21-COA-0180 530 W. Oak St.

Old Louisville Architectural Review Committee Public Hearing

Request

Primary Structure Front – PVA 2022

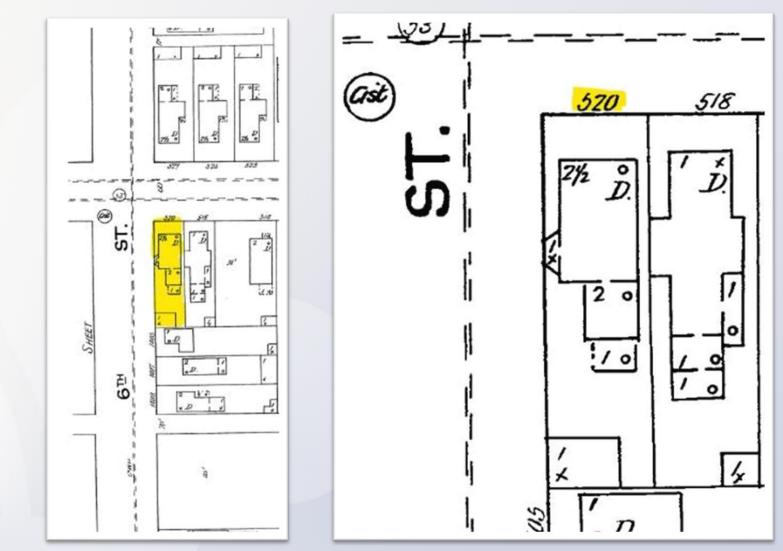
- Certificate of Appropriateness: requesting approval for after-the-fact painting of a previously unpainted brick storefront façade
- Current grey paint is primer only; applicant plans on a warm red tone to match existing historic brick
- Applicant wishes for paint to be a stop-gap for continued maintenance issues as he works towards a larger renovation of the storefront façade

- The property is zoned TNZD and is within the Traditional Neighborhood Form District
- The structure was originally a 2.5-story single-family residence. It contains multiple additions, and a storefront was added to the front which was later filled in sometime in the mid-20th century.
- This façade continues to be tagged with graffiti; the continued spray paint and cleaning had damaged the glazed brick surface

- On the basis of the information furnished by the applicant, staff recommends that the request for painting the front storefront façade be approved with the following conditions:
 - 1. The applicant shall work with staff to finalize a color that closely matches the color of the existing historic red brick.
 - The applicant shall use a "breathable" masonry paint that is compatible with and can create a strong bond with existing primer.
 - 3. The applicant shall apply for any further changes to the exterior of the building and site prior to any work taking place.
